**Committee of Experts on the Transport of Dangerous Goods
and on the Globally Harmonized System of Classification
and Labelling of Chemicals****Sub-Committee of Experts on the Transport
of Dangerous Goods****Sub-Committee of Experts on the Globally Harmonized
System of Classification and Labelling of Chemicals****Fifty-fourth session**

**Classification criteria and related hazard communication:
Work of the Sub-Committee of Experts on the Transport
of Dangerous Goods (TDG) on matters of interest to the
GHS Sub-Committee****Recommendations for Test Series 8****Transmitted by the expert from Canada and the Institute of Makers of
Explosives (IME)*****Introduction**

“18.6.2 *Test 8(c)(ii): CanmetCERL minimum burning pressure (MBP) Test*

Figure 10.4: PROCEDURE FOR AMMONIUM NITRATE EMULSION, SUSPENSION OR GEL, INTERMEDIATE FOR BLASTING EXPLOSIVES

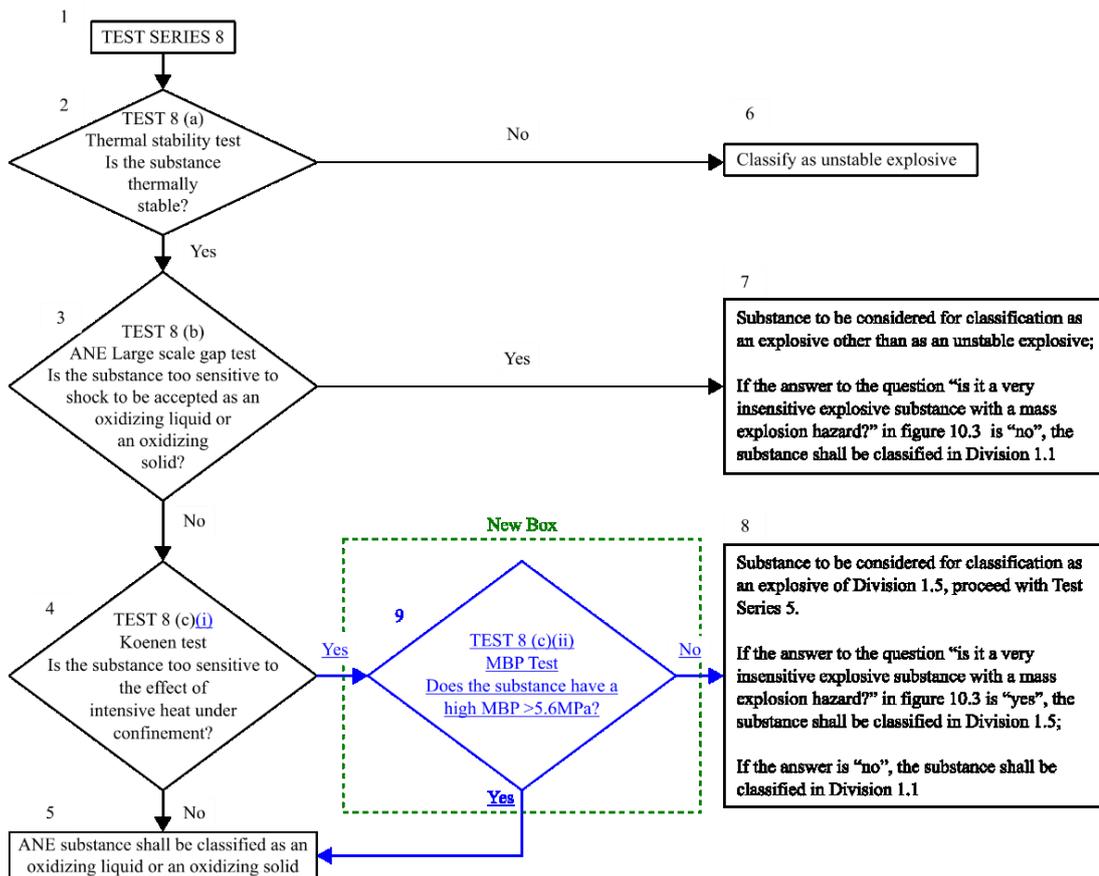
- (a) Amend Figure 10.4 of the Manual of Tests and Criteria by changing the reference to “8(c)” in the third decision box to read “8(c)(i)” and by adding the “New Box” as indicated in Annex I to this document;
- (b) Amend Figure 2.1.4 of the GHS changing the reference to “8(c)” in the third decision box to read “8(c)(i)” and by adding the “New Box” as indicated in Annex I to this document;
- (c) Amend the title of Section 18.6.1 in the Manual of Tests and Criteria to read “Test 8 (c)(i): Koenen test”, and

Amend Figure 10.4 of the Manual of Tests and Criteria as follows (*Text in blue and blue underline* = new element or text; *Text in green* = explanatory note for reference only):

Figure 2.1.4: Procedure for the classification of ammonium nitrate emulsion, suspension or gel (ANE)

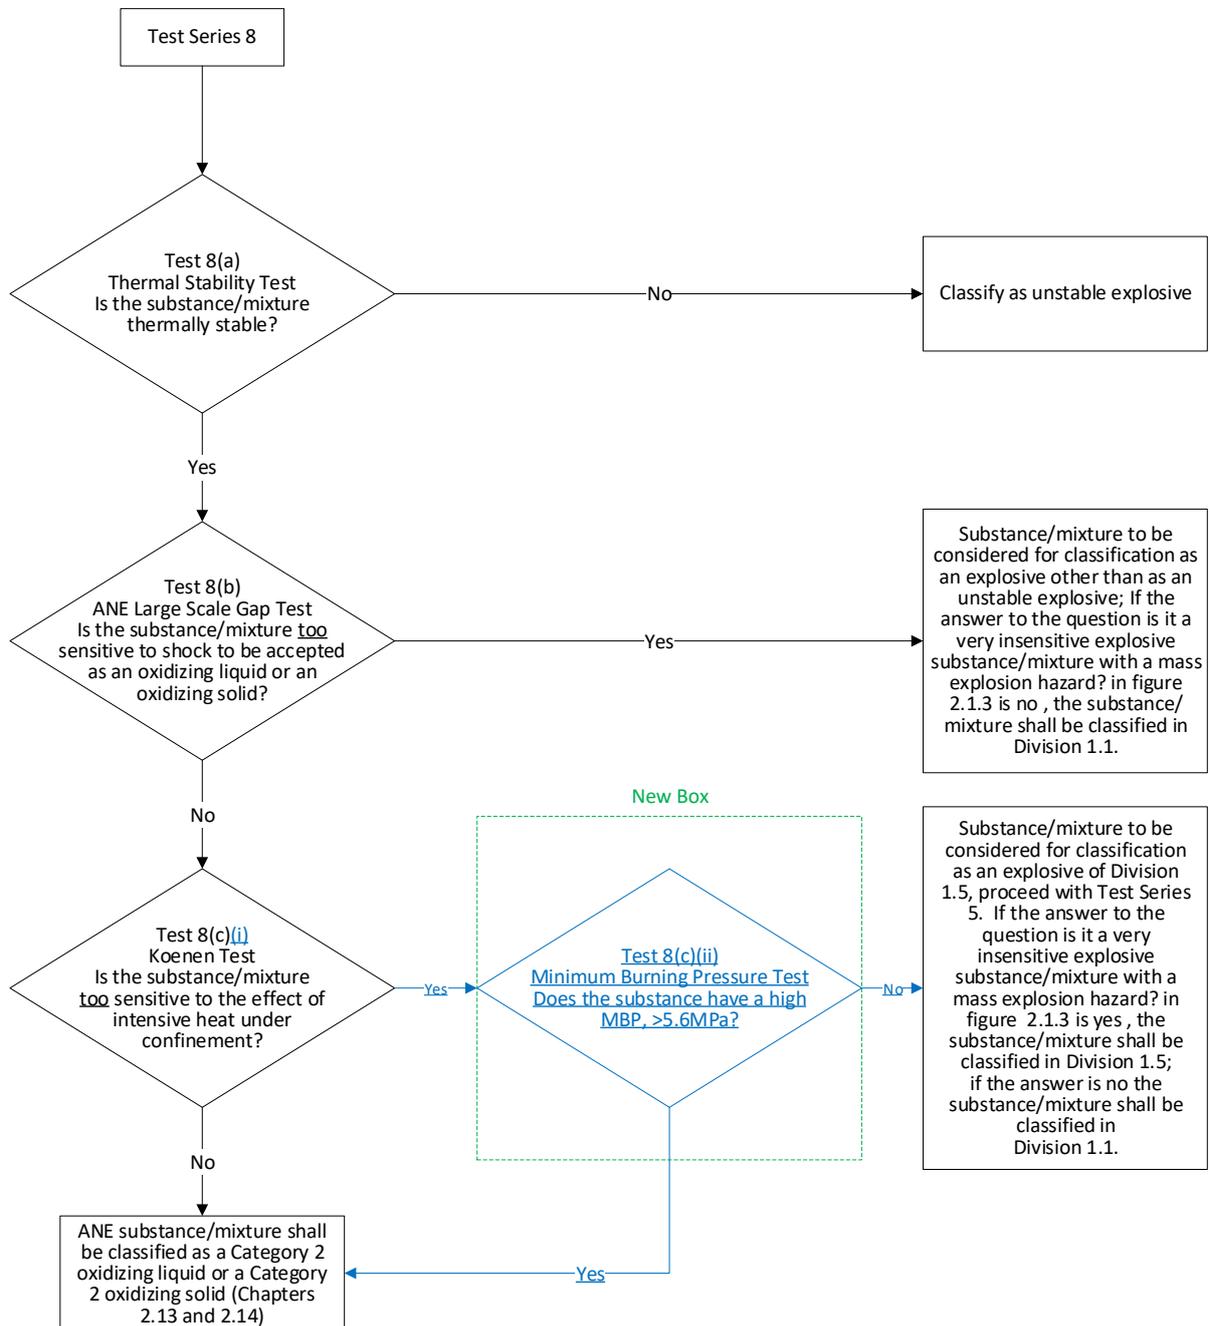
Amend Figure 2.1.4 of the GHS as follows (*Text in blue and blue underline* = new element or text; *Text in green* = explanatory note for reference only):
